**Florida  
Power**  
CORPORATION

July 25, 1985  
3F0785-31

Subject: Crystal River Unit 3  
Docket No. 50-302  
Operating License No. DPR-72  
Appendix R/Fire Protection Evaluations

EVALUATION OF FIRE  
BARRIER DEVIATIONS

FIGURE 1

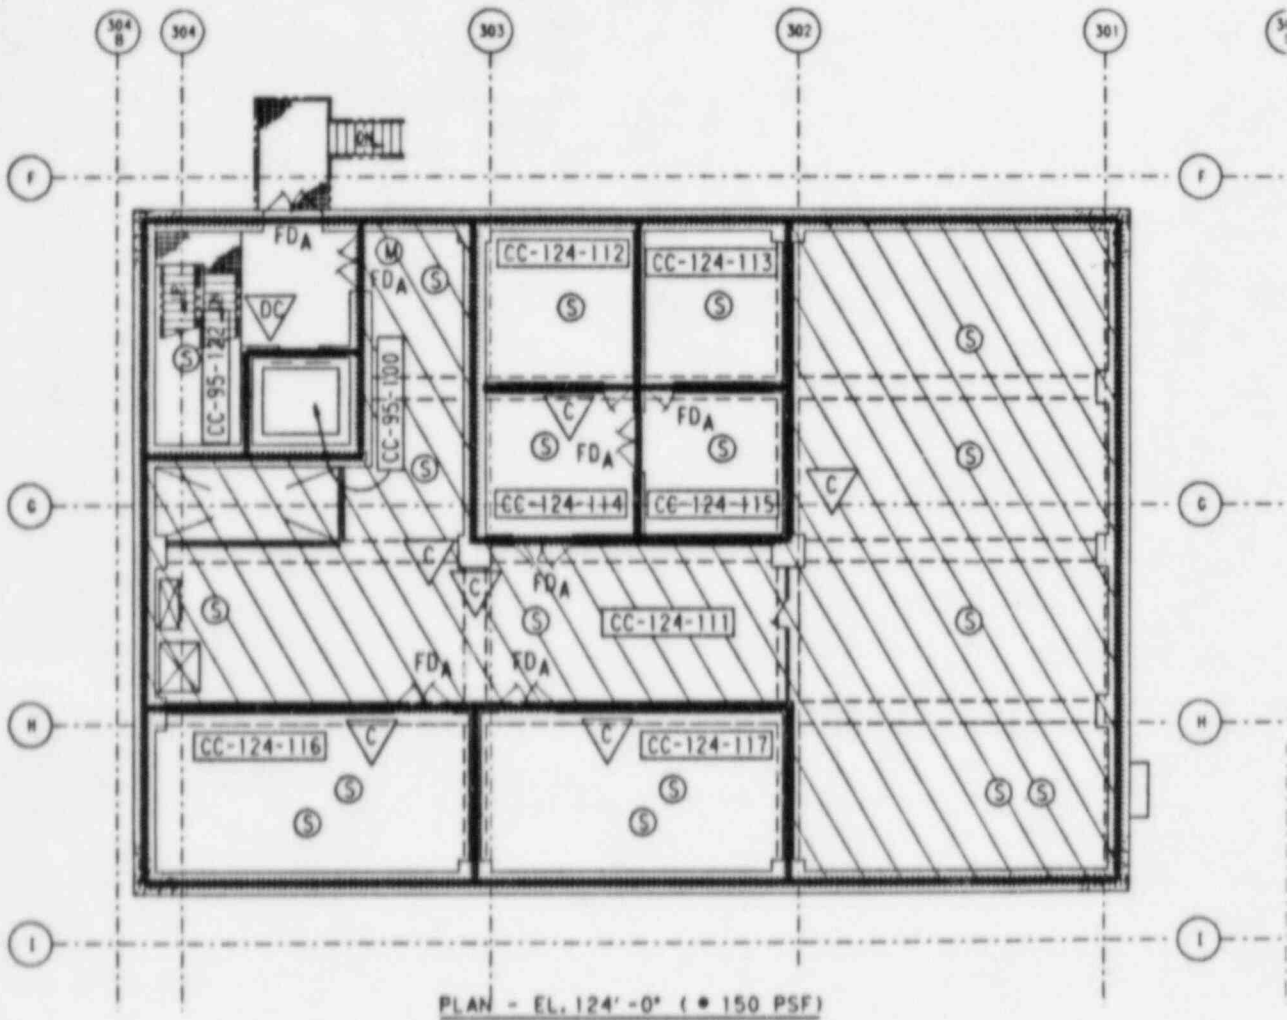
This construction results in a one-directional fire barrier from the top down. The Cable Spreading Room meets the criteria of Appendix R, Section III.G.2.c (separation by detection, automatic suppression, and 1 hour fire barrier); therefore, a deviation for only fire areas on the 124' elevation is requested. The fire areas affected are:

- CC-124-111 CRD and Communication Equipment Room
- CC-124-112 EFIC Room 'A'
- CC-124-113 EFIC Room 'C'
- CC-124-114 EFIC Room 'D'
- CC-124-115 EFIC Room 'B'
- CC-124-116 480V ES Switchgear Bus Room 3B
- CC-124-117 480V ES Switchgear Bus Room 3A

Figure 1 presents the layout of these fire areas.
